Idaho Department of Environmental Quality

Rules for Ore Processing by
Cyanidation, IDAPA 58.01.13

Minimum Plans and Specifications when single liner is required, IDAPA 58.01.13.200.03

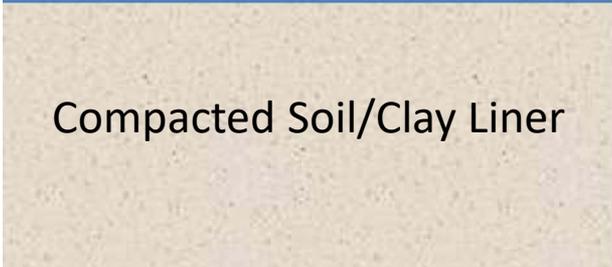
- Section 200.03.d and 03.f
- **d.** ~~A final smoothed and compacted soil layer, which~~ **Compacted clay liners (CCLs) when used shall be smoothed and** shall not contain particles in excess of point seven five (0.75) inches (nineteen (19) mm) in diameter and have a maximum coefficient of permeability of 10^{-6} cm/ sec, or comparable liners approved by the Department **and shall be placed within two percent (2%) of optimum moisture content for the CCL to achieve specified compaction and permeability criteria;**
- ~~f. Compacted clay liners (CCLs), which shall be placed within two percent (2%) of optimum moisture content for the CCL to achieve specified compaction and permeability criteria;~~
